MORELAND HALL

ADA ASSESSMENT & SURVEY

Re: ADA Accessibility Survey and Assessment – Moreland Hall

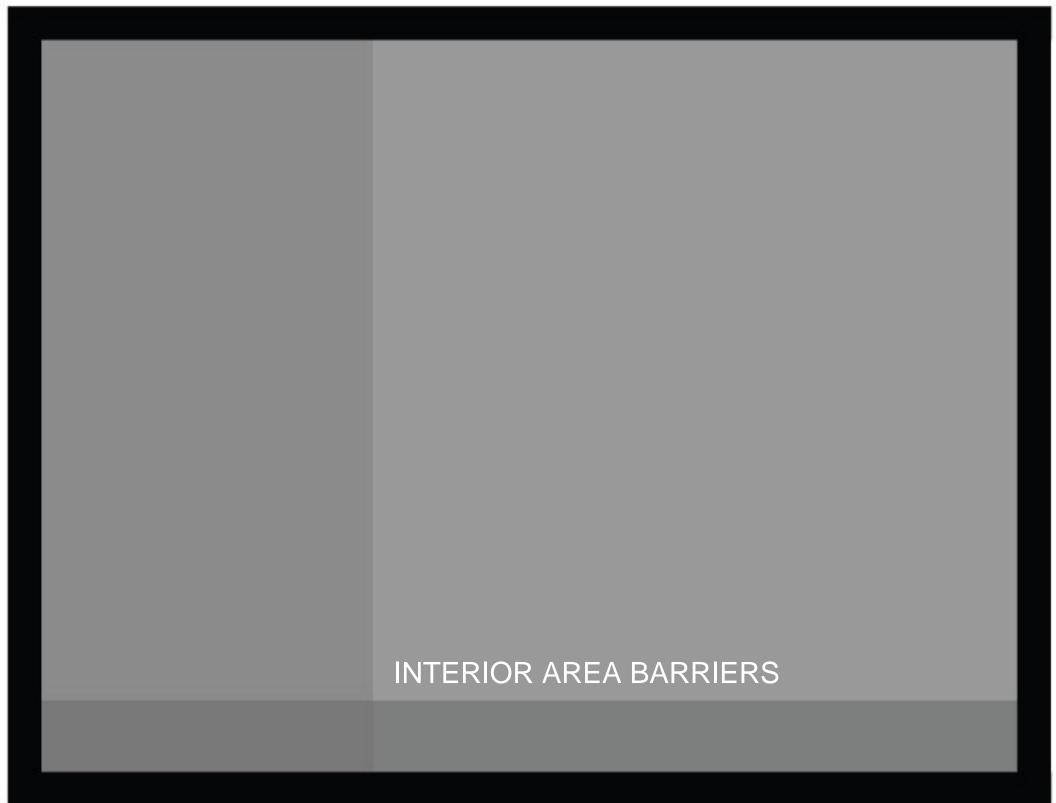
Field Date:	7/28/2011 Report Date 7/28/2011 Barrier #: 1254
Bldg Name:	Moreland Hall Reference Dwg: 1 of 5
Location:	Exterior - Southwest Parking Lot Walkway
X Coordinate:	7477797.042 Y Coordinate: 339644.602
Barrier Area:	Walkways
Barrier Type:	Cross Slope - Existing (2.1% to 3.0%)
Code References:	OSSC 1103.2.4.3 and 2010 ADAS 403.3
Performance Sta	ndard: No Quantity: LF As-built : 45
Barrier Description:	Cross slope exceeds 2.0% (2.1% to 3.0%)
Findings:	2.8% cross slope
Rec. Solution:	Low severity barrier - no remediation recommended
Barrier Severity:	4 Low Severity Cost Est \$0.00 Facility Function: Public Status: Open
Implementation	Priority: 1 Implementation Phase: Implementation Date:
Notes:	
Field Date:	7/28/2011 Report Date 7/28/2011 Barrier #: 1257
Bldg Name:	Moreland Hall Reference Dwg: 1 of 5
Location:	Exterior - Southwest Parking Lot Walkway
X Coordinate:	7477811.209 Y Coordinate: 339641.03
Barrier Area:	Walkways

Barrier Type:	Cross Slope - Existing (5.0% or more)
Code References:	OSSC 1103.2.4.3 and 2010 ADAS 403.3
Performance Sta	ndard: No Quantity: LF As-built : 45
Barrier Description:	Cross slope exceeds 2.0% (5.0% or more)
Findings:	5.3% cross slope
Rec. Solution:	Demolish existing and construct new route
Barrier Severity:	1 Necessary Cost Est \$0.00 Facility Function: Public Status: Open
Implementation	Priority: 1 Implementation Phase: Implementation Date:
Notes:
